Circular No. 105 / 2024

Field Safety Notice of Stationary Radiological Equipment from Siemens Healthcare GmbH.

## **Safety Advisory Notice**

## **Re: Potential risk of unintentional lowering of the support arm for display ceiling suspension / display wall suspension**

Figure 1 Display ceiling suspension  
with ceiling tube circled

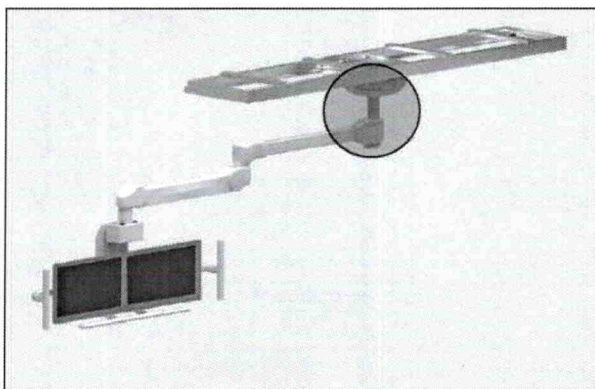
Please visually inspect the mounting screw on the ceiling tube (Figure 1) or wall tube (Figure 2) of the display suspension as far as this is possible from the ground.

If the mounting screw is missing, or if the screw head protrudes or is broken, discontinue use of the system immediately. Please inform the Siemens Healthineers customer service. Furthermore, if the display ceiling/wall suspension has lowered, discontinue use of the system immediately and inform customer service of the issue.

In case the visual inspection of the mounting screw does not show any abnormalities, you can continue to use the system. Nevertheless, until the system has been checked by Siemens Healthineers customer service with the planned field action, we recommend:

- not to swivel the support arm of the display ceiling/wall suspension to the mechanical limit with great force and
- to ensure that there is no one under the display ceiling/wall suspension when positioning the displays.

Figure 2 Display wall suspension  
with wall tube circled

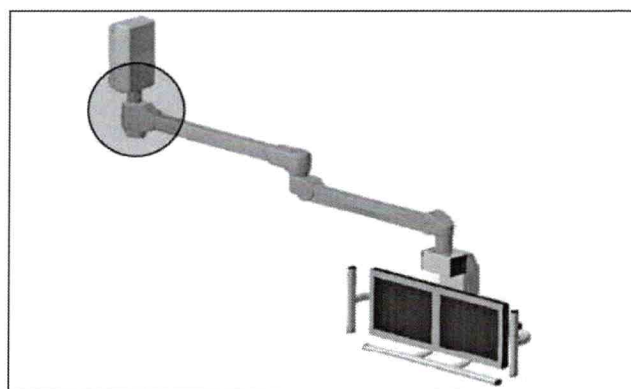
For display wall suspension: The tube attachment on the wall suspension is identical to the tube attachment on the display ceiling suspension.

Figure 3 Correct:  
Mounting screw available  
and no visible damage

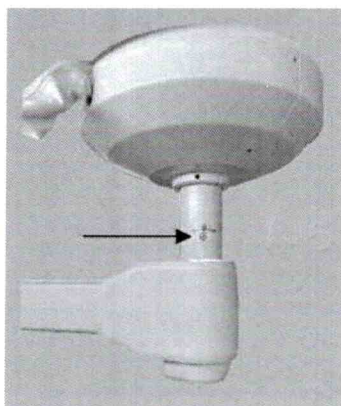
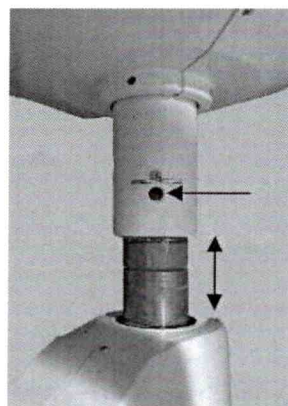
Exemplary illustration of mounting screw and tube attachment on the display ceiling suspension showing the correct (figure 3) versus incorrect (figure 4) tube attachment:

Figure 4 Incorrect:  
Mounting screw missing  
and/or lowered support arm
